## Memorandum - Final

To: Neil Jensen – City of Shoreline c/o Darren Murata - DOWL  
Site: 20<sup>th</sup> Ave NW Sidewalk Project  
Re: August 2, 2023 Site Meeting  
Date: August 11, 2023  
Project Arborist: Tyler Bunton  
ISA Certified Arborist PN-8715A  
ISA Qualified Tree Risk Assessor  
Attached: Table of Trees  
Tree Site Map

This memorandum documents my site meeting with Neil Jensen of the City of Shoreline and the property owners of 19308 20<sup>th</sup> Ave NW, Shoreline, WA on August 2, 2023. At this meeting we discussed the planned work within the right-of-way adjacent to their property on 20<sup>th</sup> Ave NW. I have attached the table of trees for this project and our most recently review annotated plans which show the locations of the trees for reference.

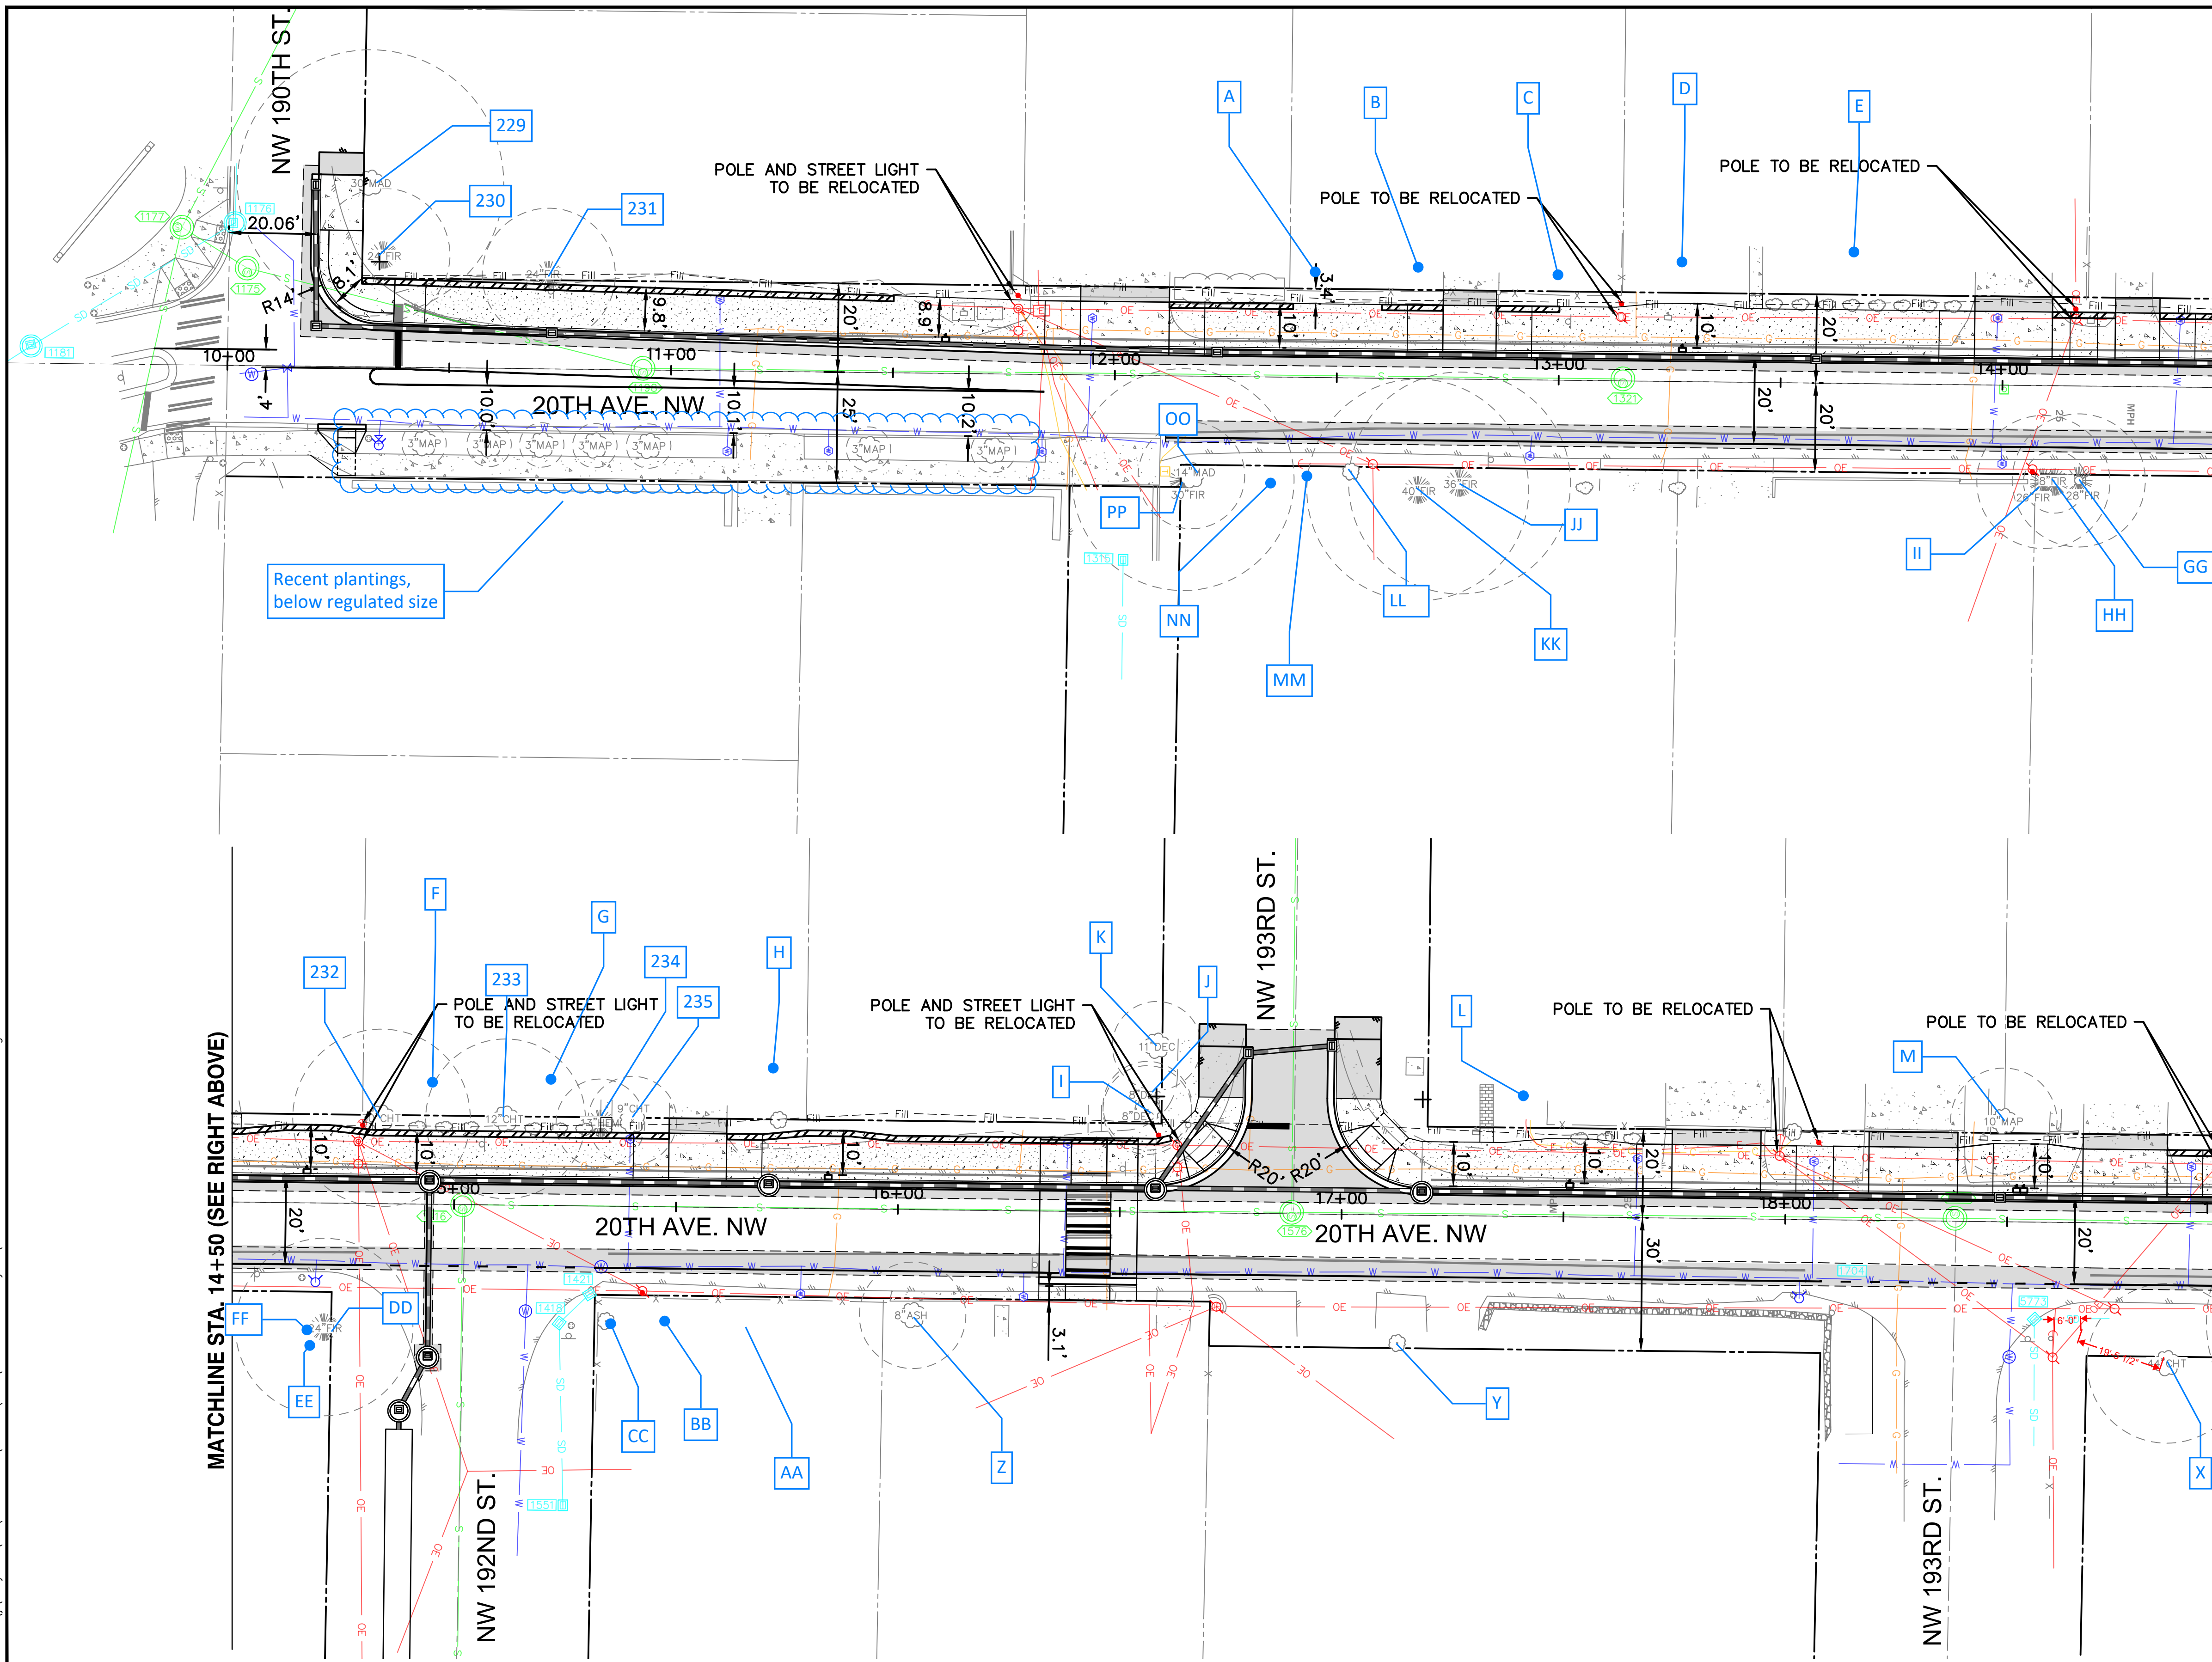
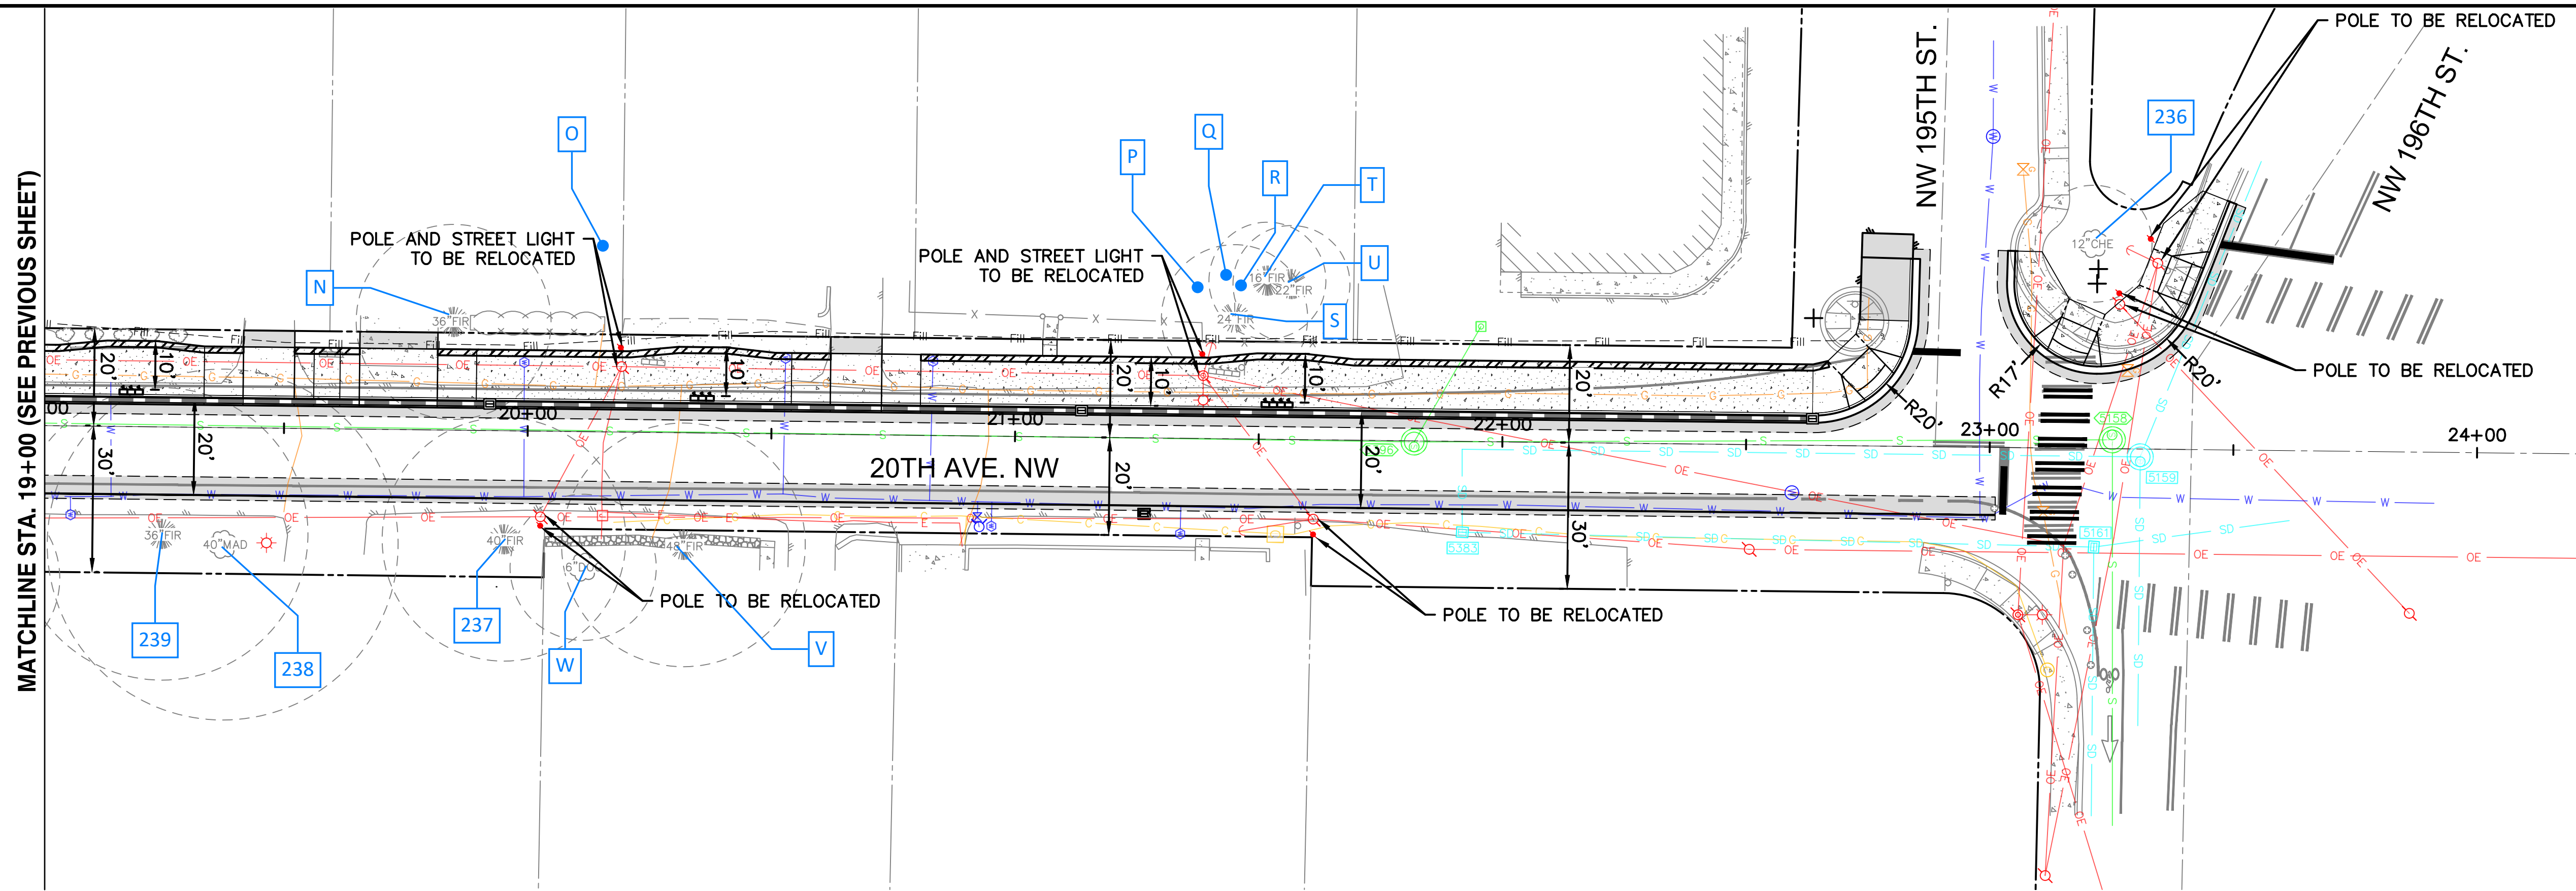
As of August 2, 2023 two holes have been dug within the recommended tree protection zones of trees X and 239 without a Tree Solutions Inc. arborist monitoring. There is also additional work planned within the recommended tree protection zones of these trees including installation of a fire hydrant approximately 19 feet south-southwest of tree X and a valley drain along the road edge west of the trees.

To minimize disturbance to tree X I recommend installing the fire hydrant at another location on the site. If the hydrant must be placed in this location the excavation should occur according to the existing project specifications.

I observed that the soil around trees 238, 239, and X is sandy which typically results in more deeply rooted trees. I also did not observe any lifting of the asphalt road adjacent to trees 238, 239, and X which indicates that it is unlikely there are large roots directly below the surface of the road.

Within the recommended tree protection zones the asphalt should be removed carefully with an excavator with a flat front bucket to minimize the amount of disturbance to the soil below the road. After the asphalt is removed the remainder of excavation should occur according to the project specifications.

If pneumatic air excavation occurs when the soil is dry water must be available on-site to wet the soil and minimize dust production.
